SEAT HEATER

■ DESCRIPTION

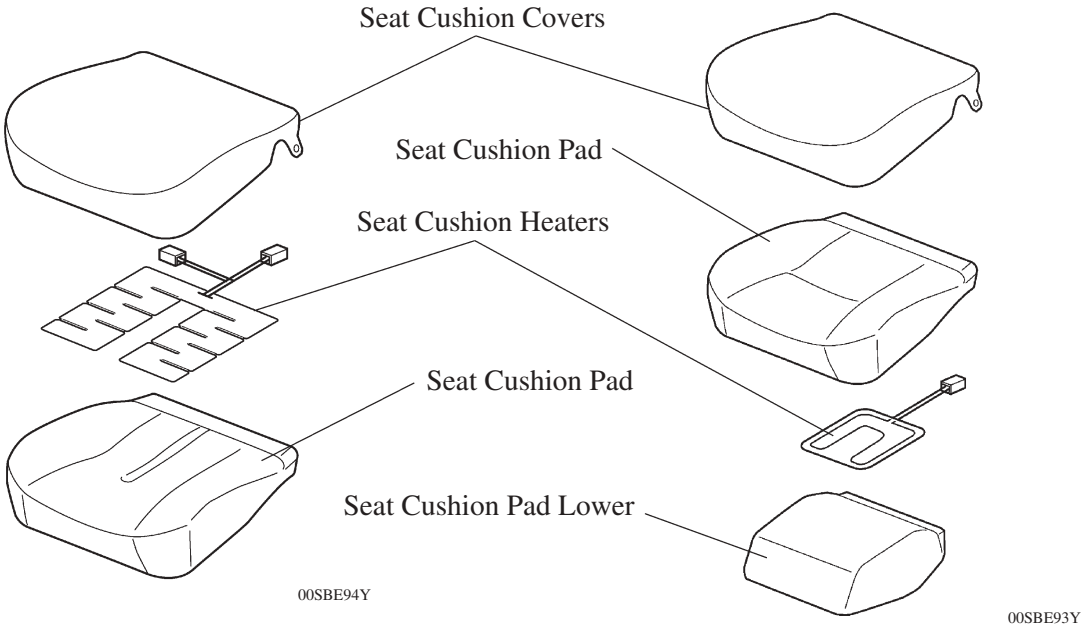
- Seat heaters are available as optional equipment in the driver seat and front passenger seat on the cold area specification LHD models for Europe.
- On the previous models, the seat cushion heater was integrated into the seat cushion pad, but on the new models, the seat cushion heater is integrated above the seat cushion pad.
- It is operated ON/OFF by a heater switch located on the center console.
